CITY OF WINTER PARK PLANNING AND ZONING BOARD

Staff Report March 1, 2016

SPR 1:16 Request of Vince Smith Construction for approval of a new one-story, single-family home located at 716 Kiwi Circle on Lake Osceola.

REQUEST OF ICON RESIDENTIAL FOR: COMPLIANCE WITH THE CONDITIONS OF THE CONDITIONAL USE APPROVAL TO REDEVELOP THE 3.45 ACRES OF PROPERTIES COLLECTIVELY REFERRED TO AS 1800 LEE ROAD FOR A 30 UNIT TOWNHOUSE DEVELOPMENT (CLUSTER HOUSING), ON THESE PROPERTIES ZONED R-2.

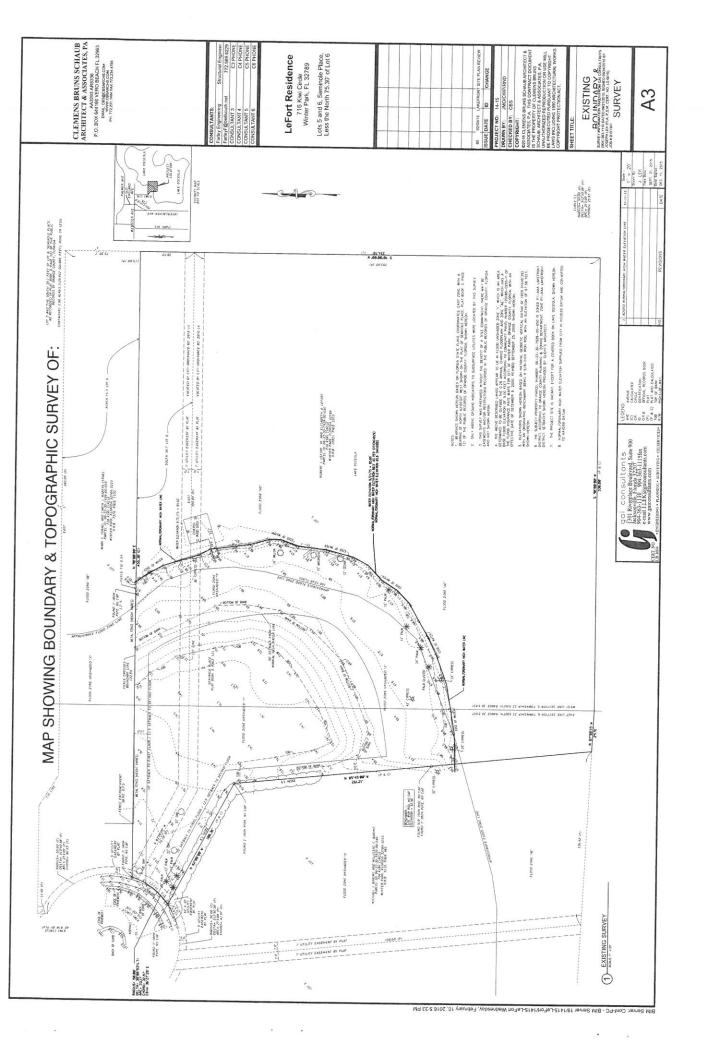
VIEW FROM THE LAKE: This lot has over seven feet of grade drop throughout the length of the lot. Because of this severe grade drop, to keep the house and pool level, the retaining wall along the length of the guest house located in the western portion of the site extends approximately four to six feet above the natural grade. The pool deck also extends approximately five feet above the natural grade. The applicant and homeowners are aware that per code, the swimming pool/pool deck cannot be higher than three feet above the existing grade on the lakeside of the pool deck, and that the facade of these retaining walls facing the lake shall be screened with landscape plantings across the length of the retaining wall except for any sections involving stairs down to the lakefront.

However, because of the seven feet of grade drop throughout the length of the lot, the Planning and Zoning Board may approve the pool deck and retaining wall to be higher than three feet above existing grade on the lakeside.

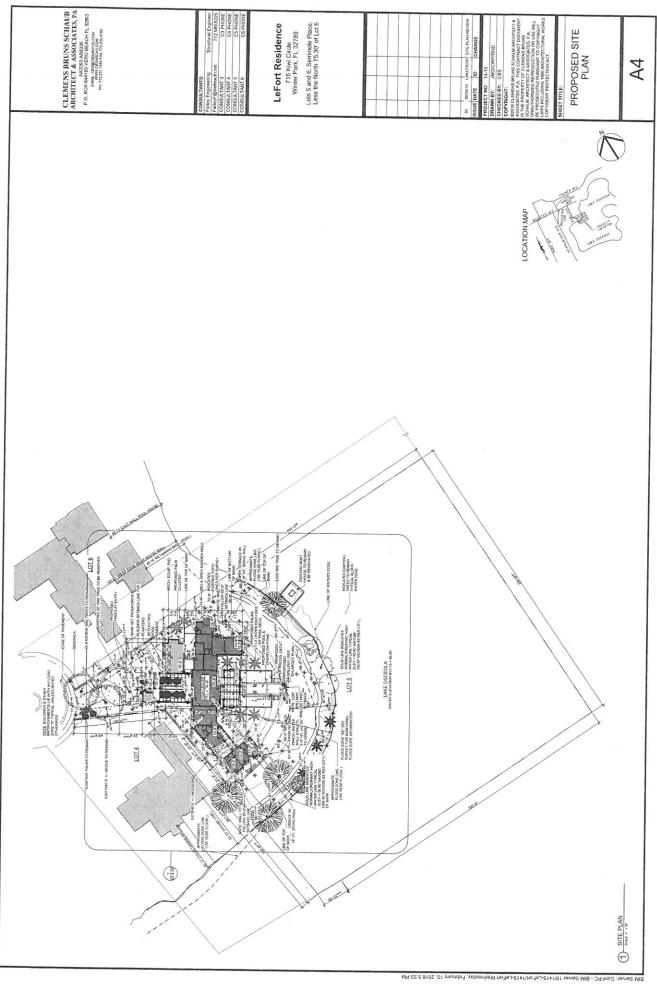
Furthermore, the spillway from the proposed pool deck extends into the required 50 foot setback from the lake; however, this area is minimal and Staff feels that this extension into the required setback does not hinder the objectives of the lakefront review criteria.

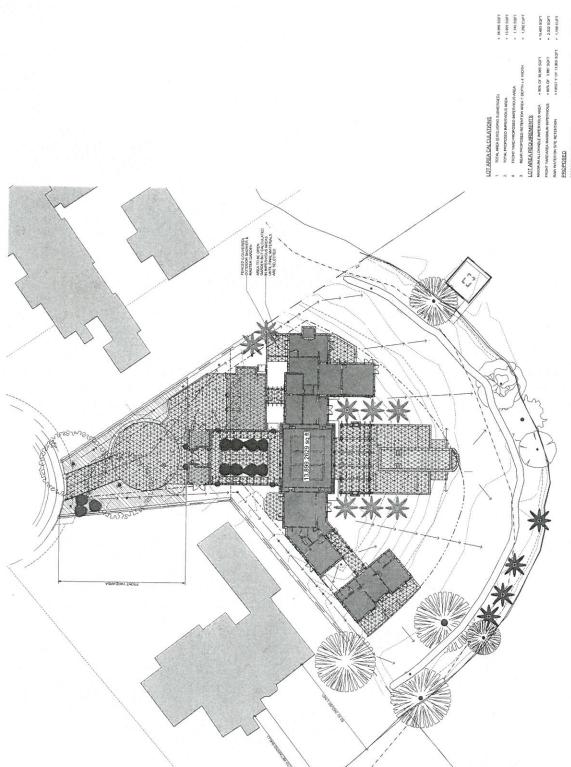
STORM WATER RETENTION: A storm water swale extending the length of the lot is shown on the plan in the area close to the lakeshore, and also pipe drains are planned at the top of the lot to accommodate the driveway runoff, and carry the runoff downwards through the lot. There is more than ample land provided and sized to meet the City's code requirement.

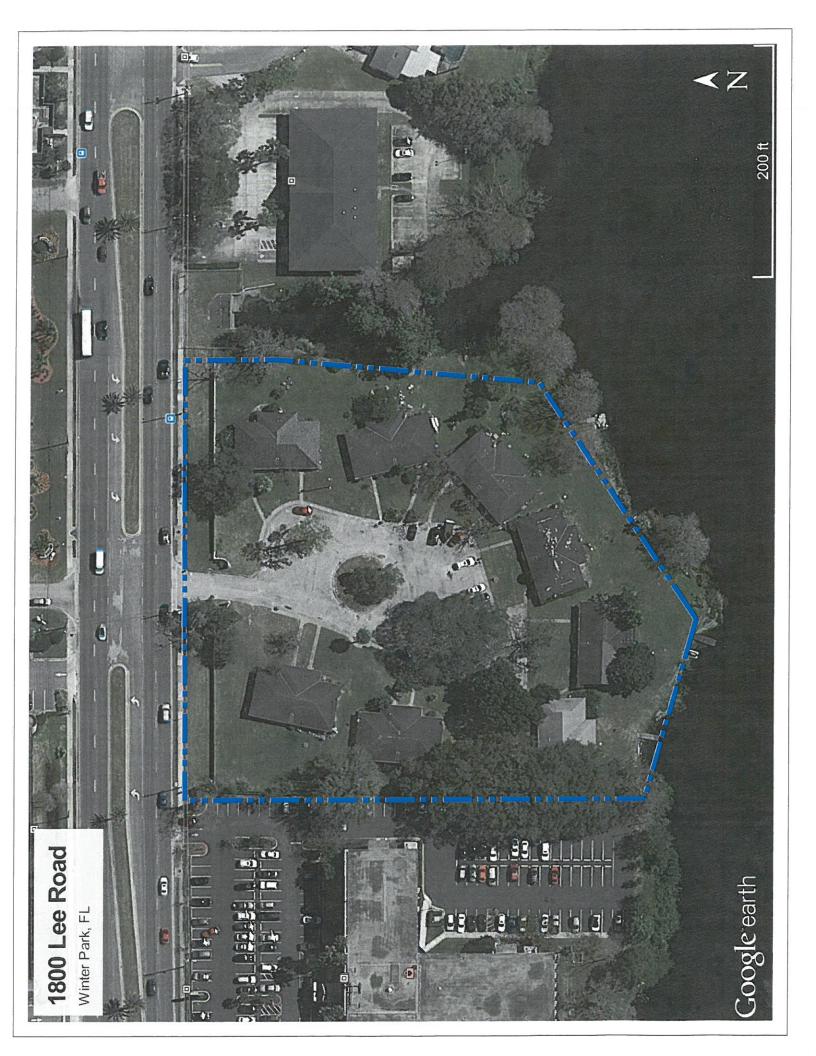
The project also proposes to redevelop the privacy wall that exists along the Lee Road frontage. The existing wall was not in good condition structurally in some sections due to tree root/growth impacts since 1964. The applicant was approved in the original Conditional Use submittal to move the wall closer to Lee Road, at a 10 foot setback and for an exception for 7 feet-4 inches of wall height with 8 foot columns, in lieu of the typical code maximum of 6 feet, given the traffic volumes and traffic noise from the 35,500 cars a day going by on Lee Road. However, the condition provided the City an opportunity to look at the design and materials since this "front door" wall is the only thing that most residents will see of this project.

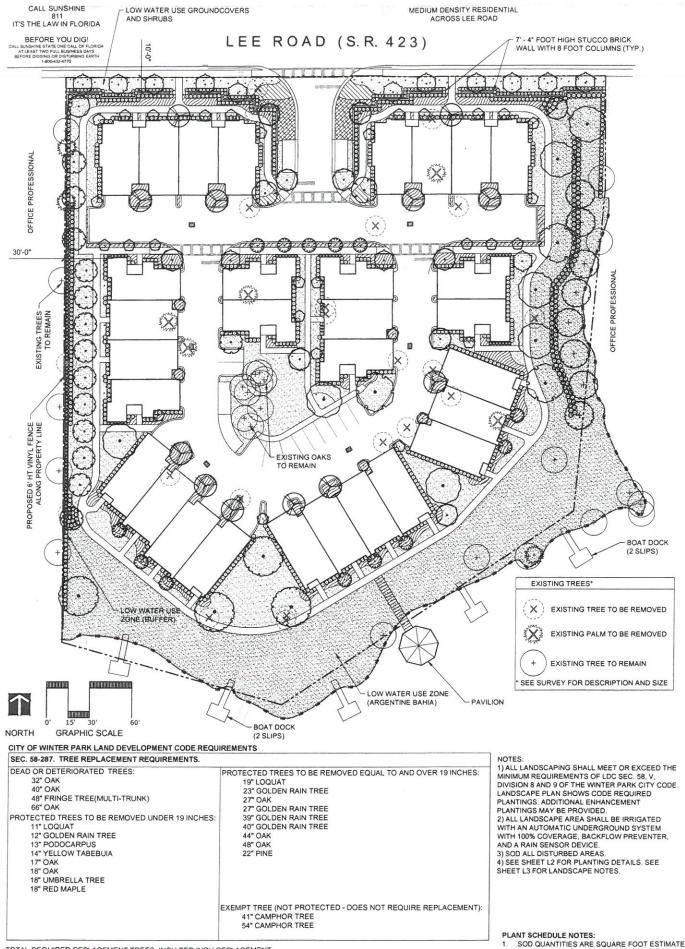
Per the subdivision code requirement the wall site plan design includes jogs or articulation which will vary the distance from the sidewalk, so that the wall is not completely linear. It also 'wraps' the western corner back 25 feet to the start of the parking spaces for the adjacent office building so that you can't see into the project while traveling east on Lee Road. Along the western border with the office building will also be a six foot vinyl privacy fence which complies with Code.

CONCEPTUAL PAVILION DESIGN NORTH ELEVATION

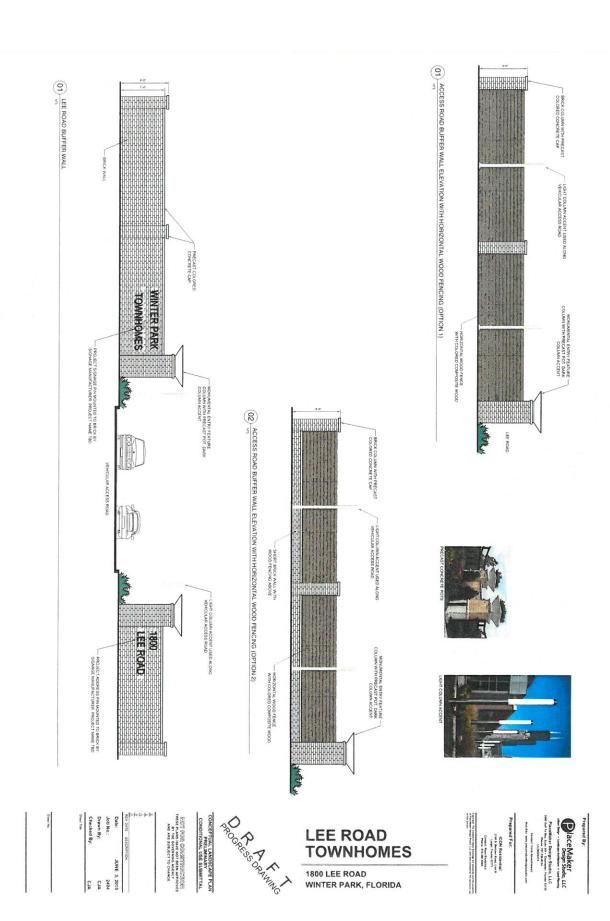
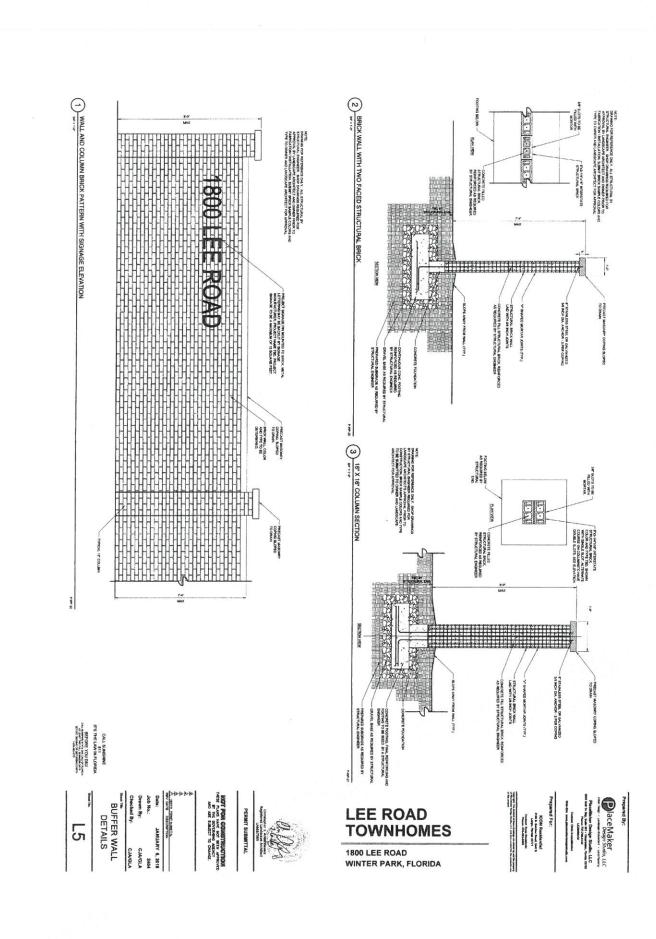
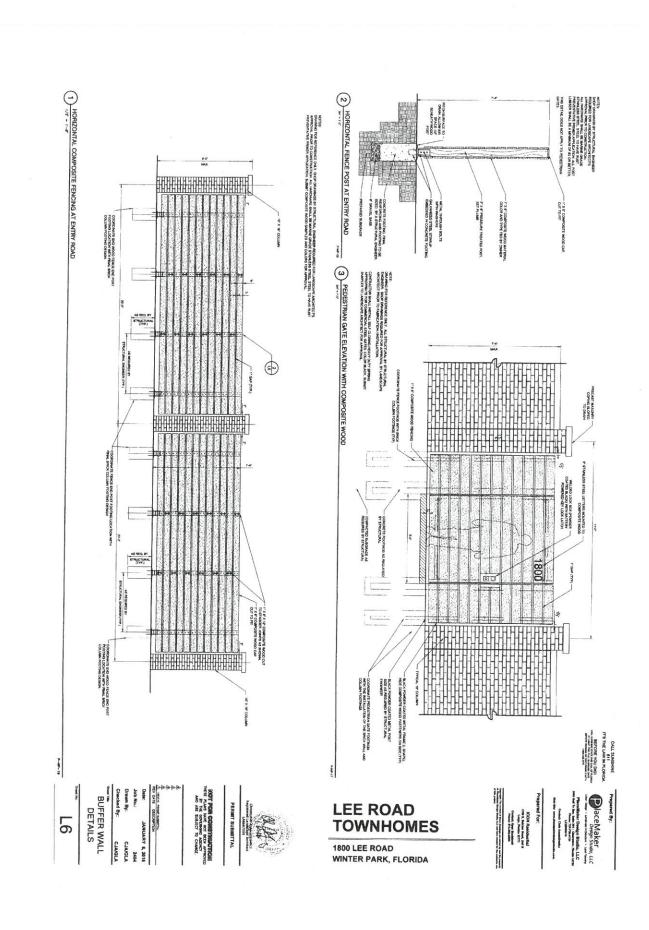
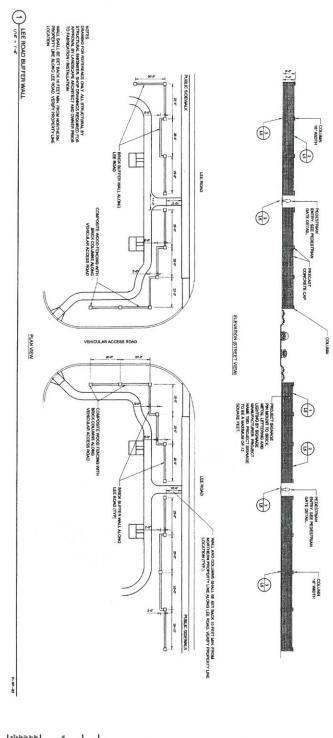
The project also proposes a lakefront gazebo that the residents can use for passive enjoyment of the lake. Since that structure is within the 50 foot lakefront setback, Planning and Zoning Board approval is required. The gazebo is a 600 square feet, open sided structure that is 11 feet tall. The planning staff is comfortable with the design and dimensions of all of these lakefront amenities.
